Canal Winchester

Meeting Agenda

Monday, February 10, 2020

Planning and Zoning Commission

A NORTH ELEVATION
SCALE: 3/32" = 1'-0"

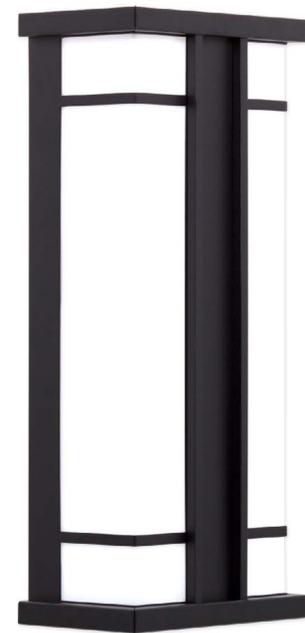
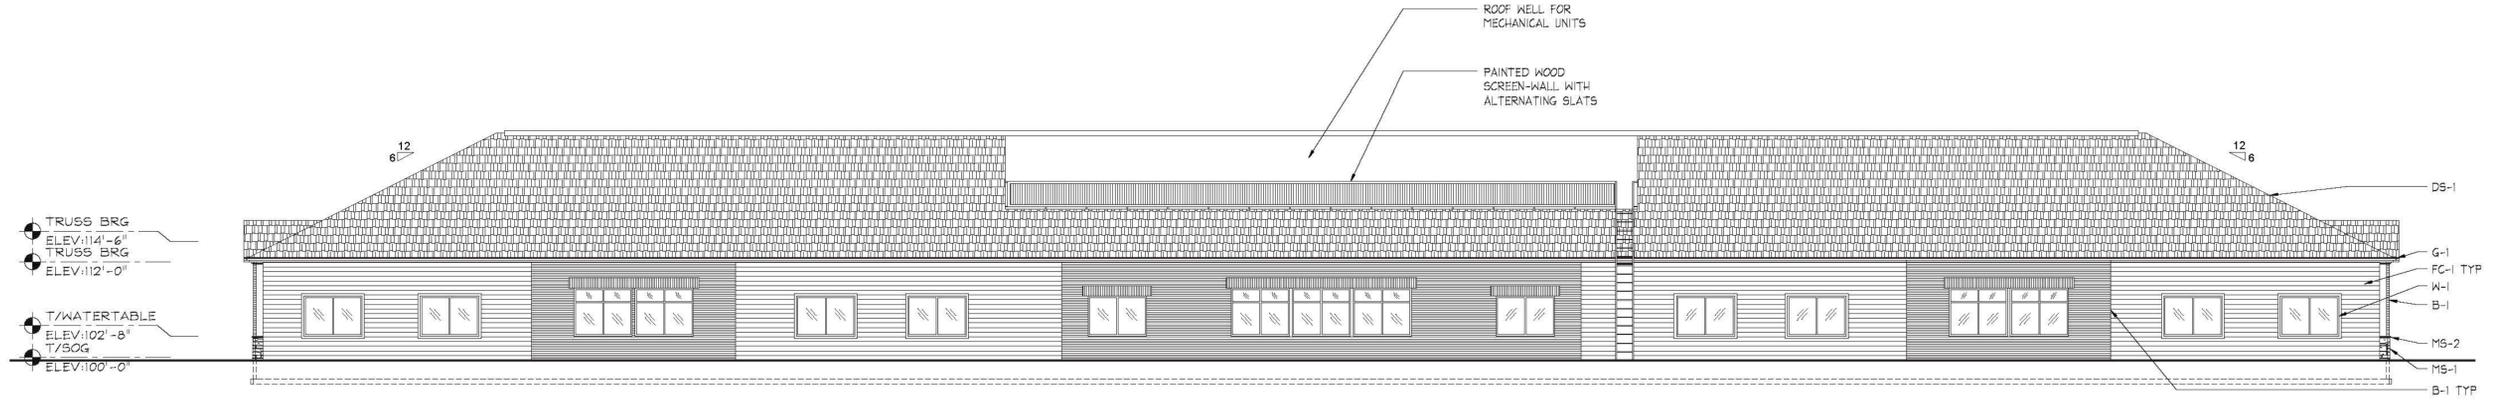
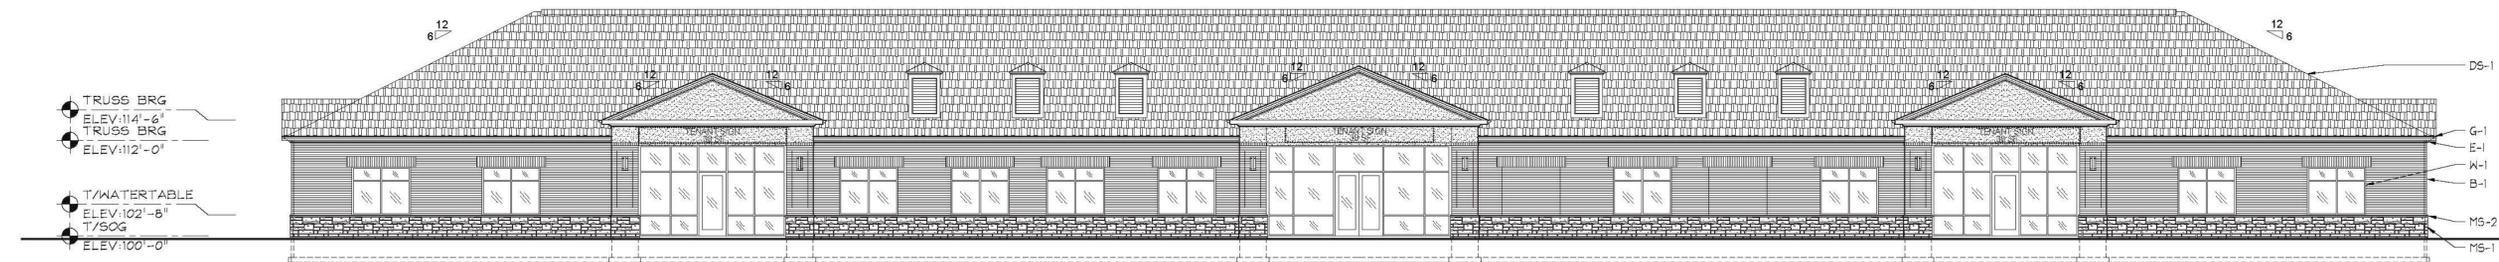
Chapter 1199.06(a) of the Commercial Development Standards require that building wall lighting must be decorative fixtures. The fixtures shown by the applicant meet this requirement.

Staff is recommending that the site development plan is approved as presented.

EXTERIOR ELEVATIONS

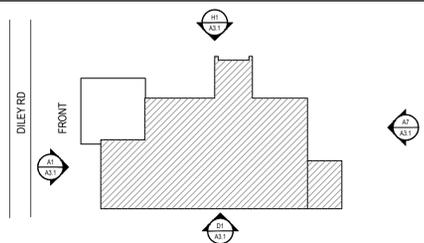
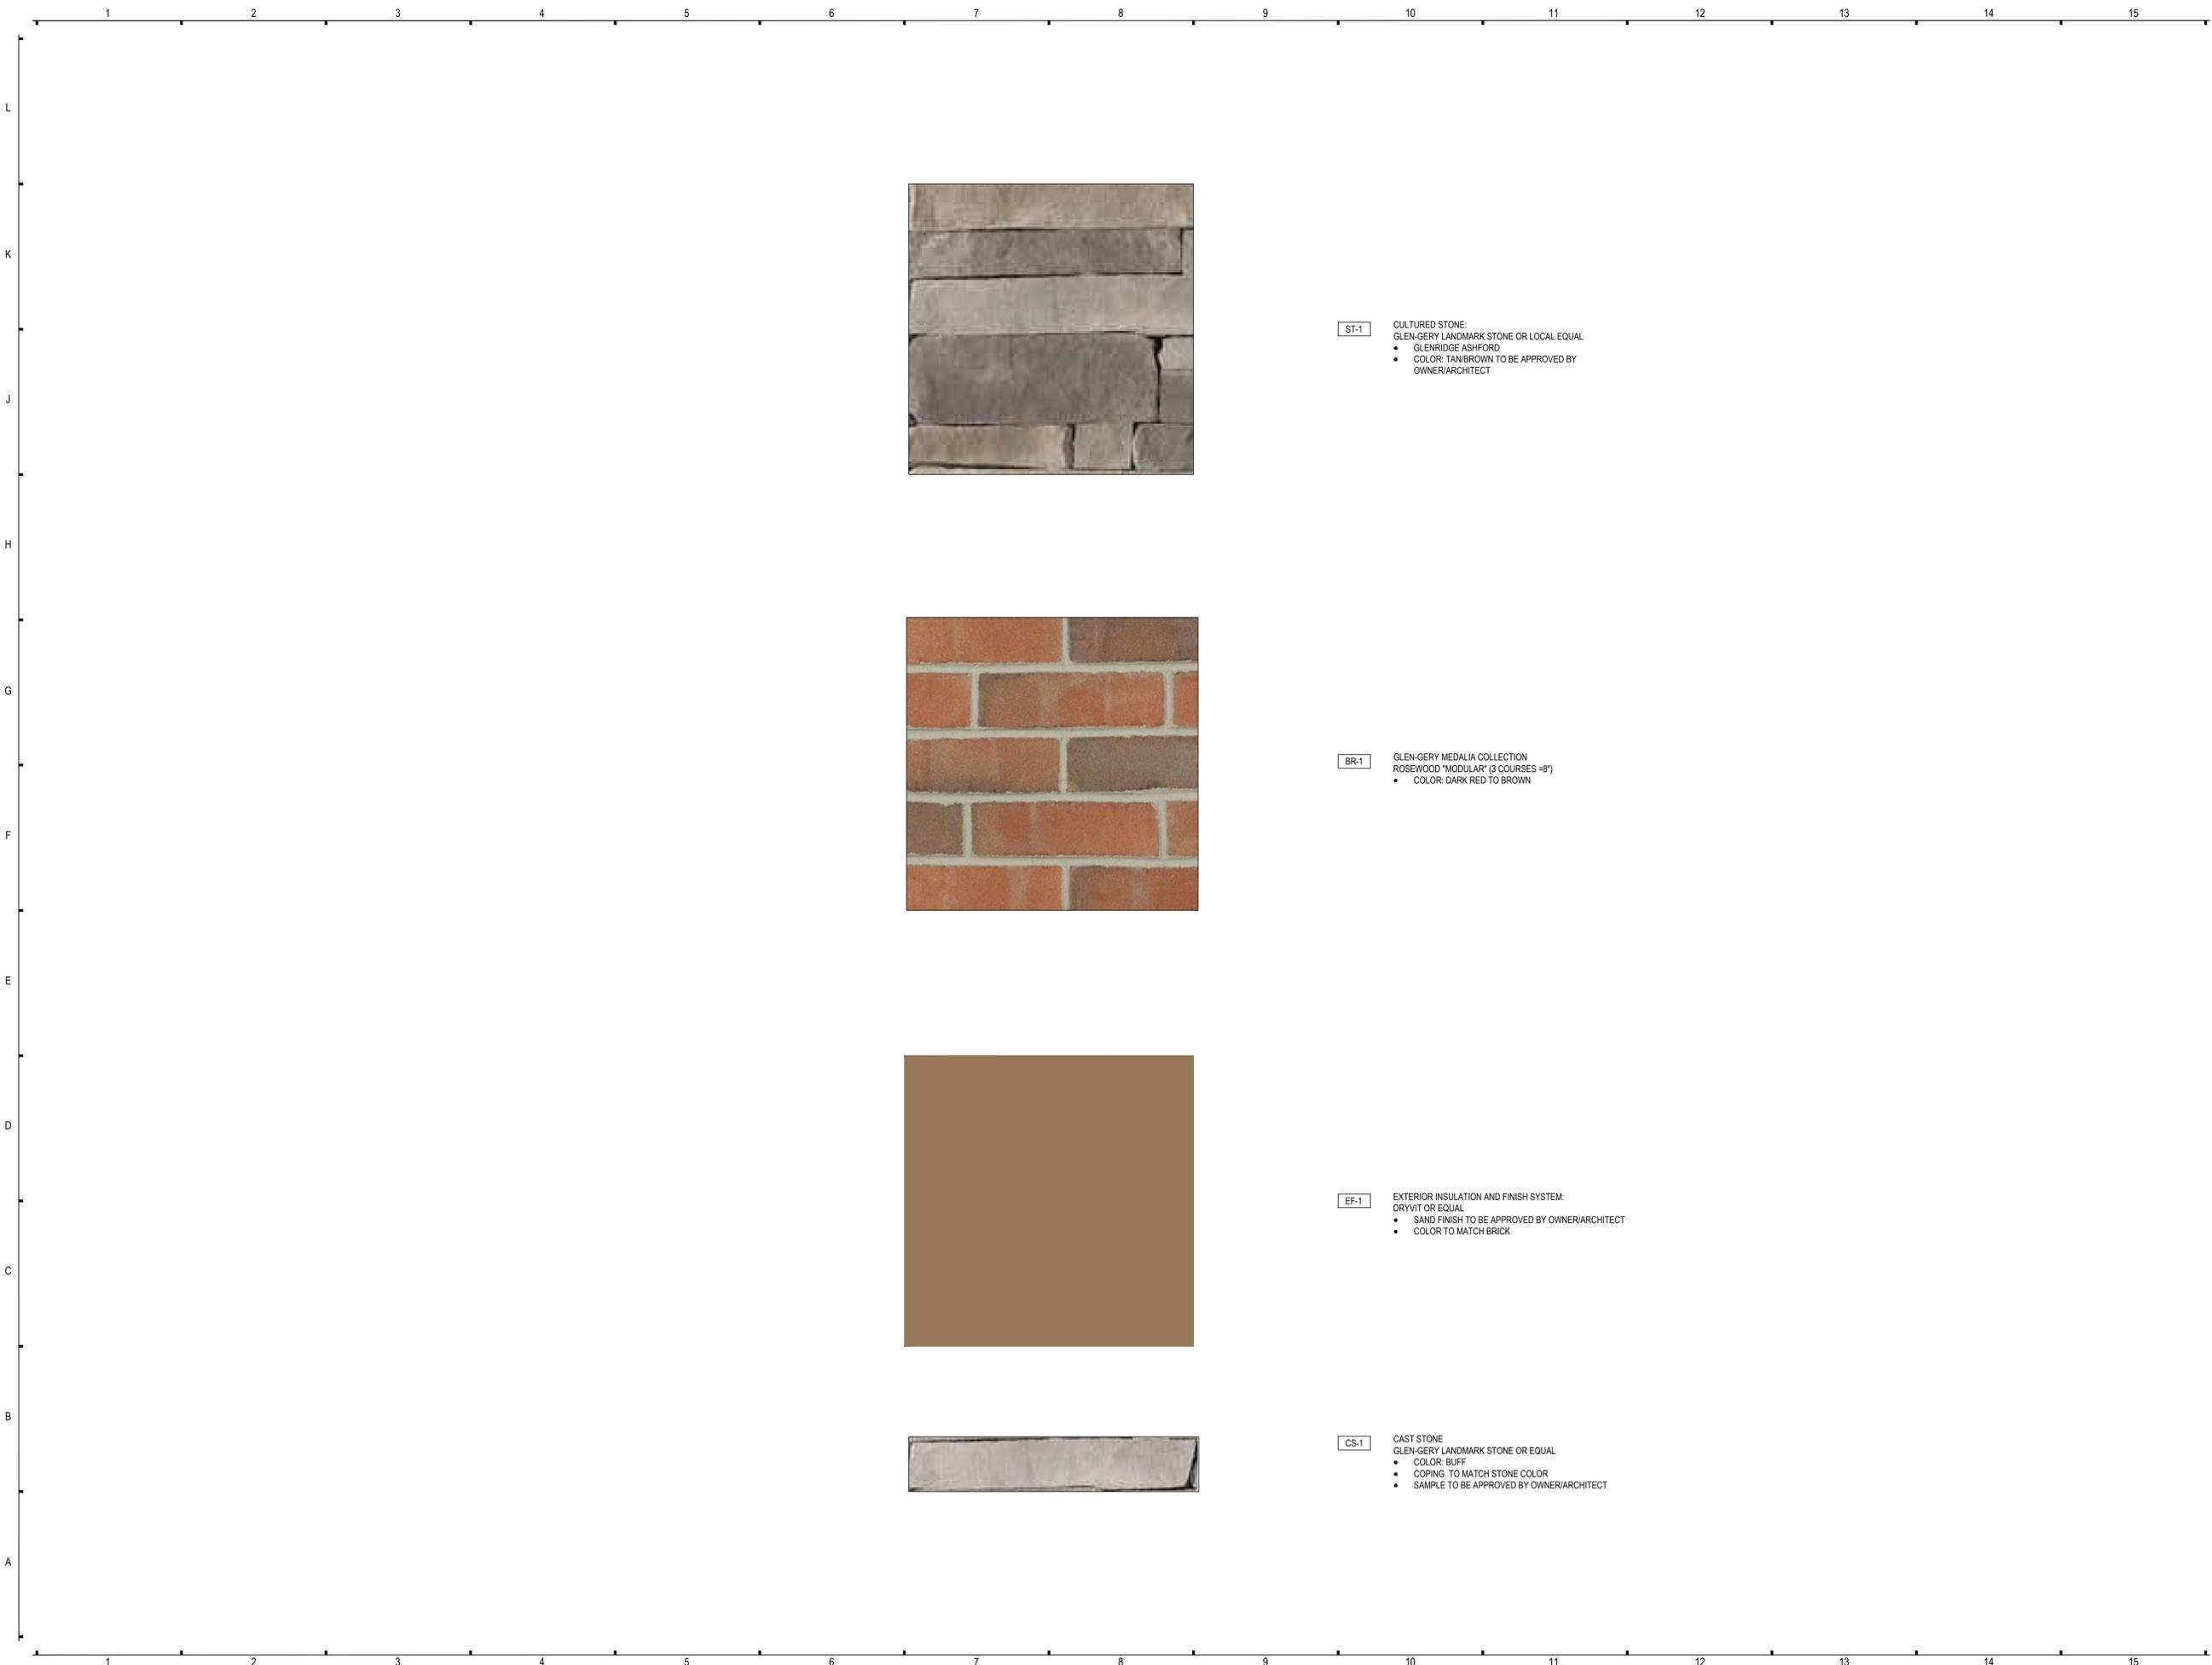
The Meijer outparcel development pattern book requires that similar colors, materials and textures of the buildings need to match that of the Meijer store. Details and features on the Meijer building should be incorporated to the smaller scale of the outparcel developments. All sides of the buildings shall express a consistent architectural detail and character.

The outparcel development pattern book states that buildings shall be designed to reduce their visual impact and provide a human scale by installing elements such as planters and site walls, architectural wainscot treatments, pronounced eaves and cornices, subtle changes in color and texture and breaking down buildings into distinct masses while providing covered pedestrian frontages and recessed entries. The development pattern book prohibits gradation in paint color, extended bands of vibrant or contrasting colors/logos, long uninterrupted expanses of glass and floor to ceiling glass storefront treatments.

HALO LIT LETTERING AND BORDER

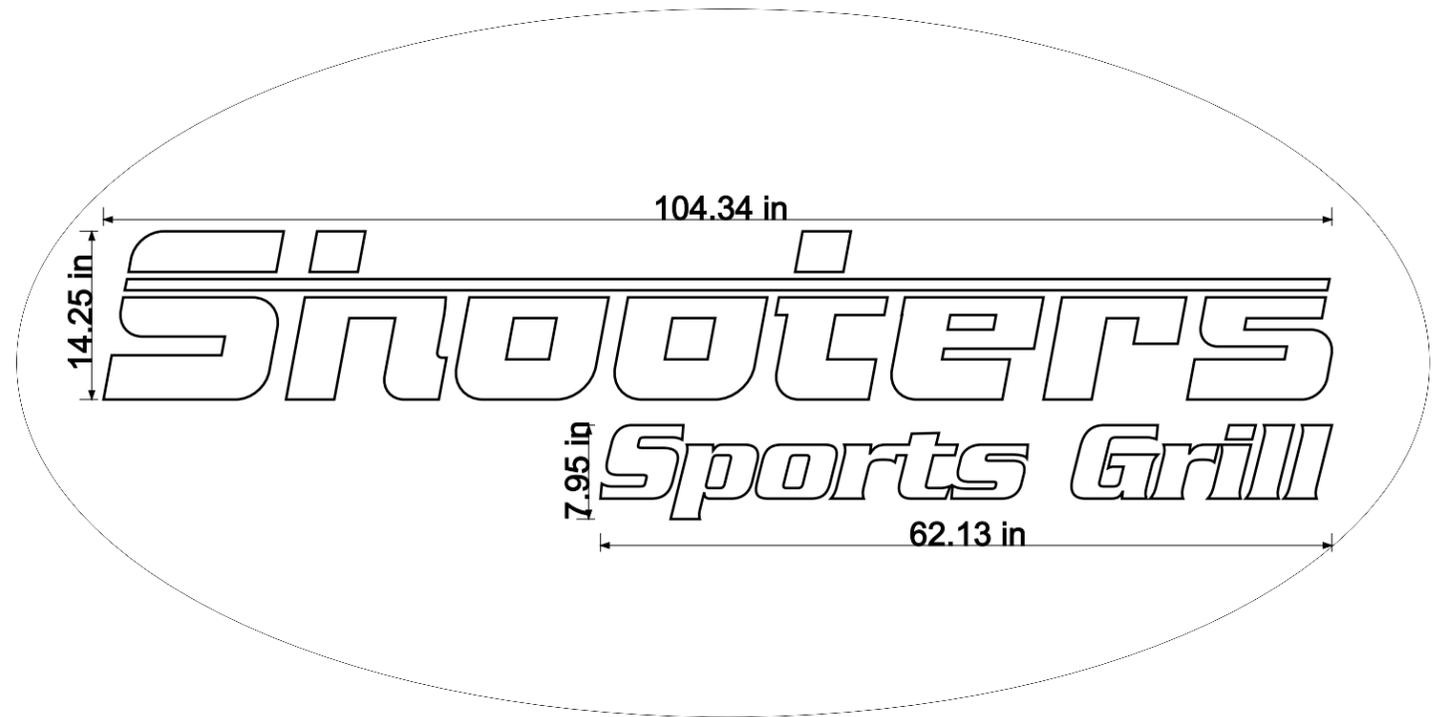
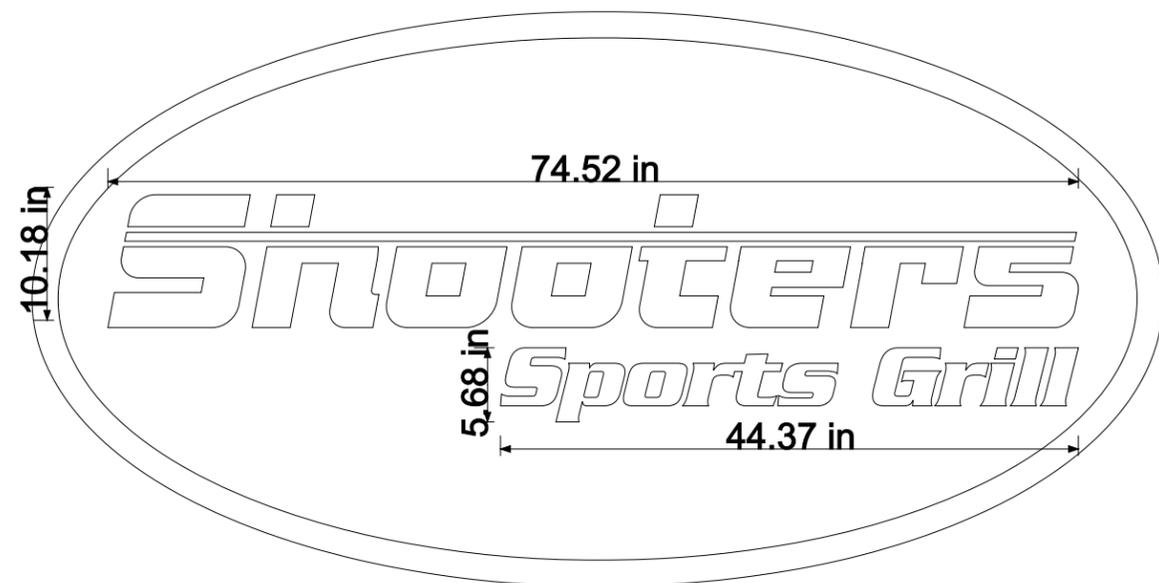
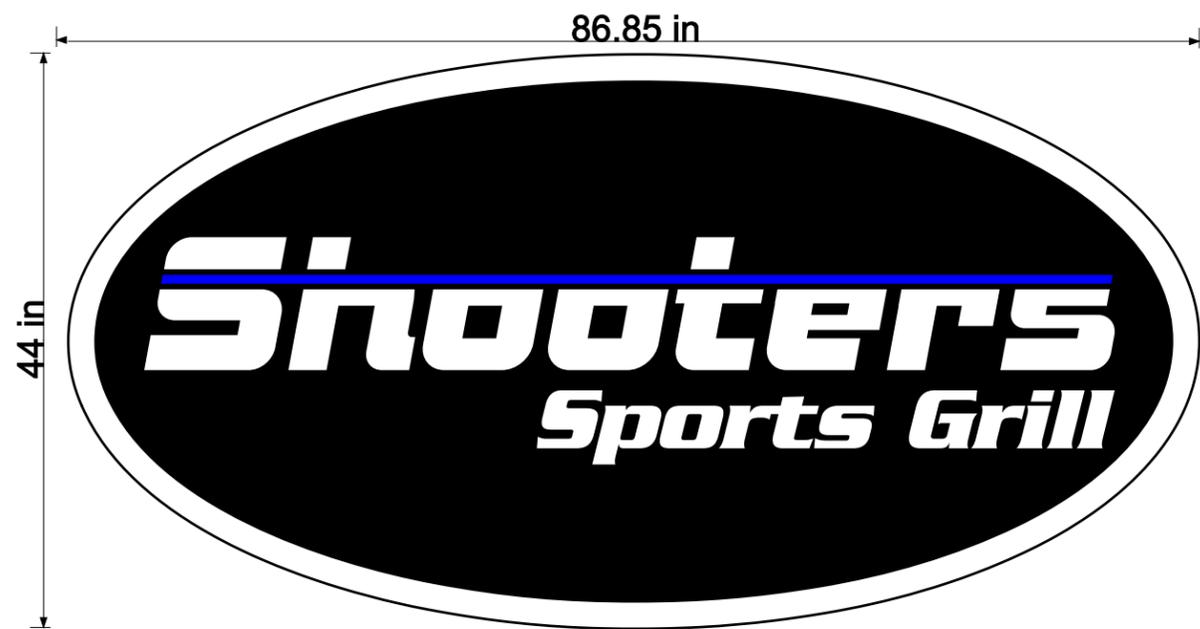
The applicants signage drawings show an internally illuminated cabinet box sign that does not meet criteria 2a or 2b of the above signage restrictions. Staff is recommending that the applicant revise the sign drawings to comply with the development text.

1. The electric transformer be screened on three sides by the arborvitae shown on the plan.
2. The wall signage be amended to meet the development text.
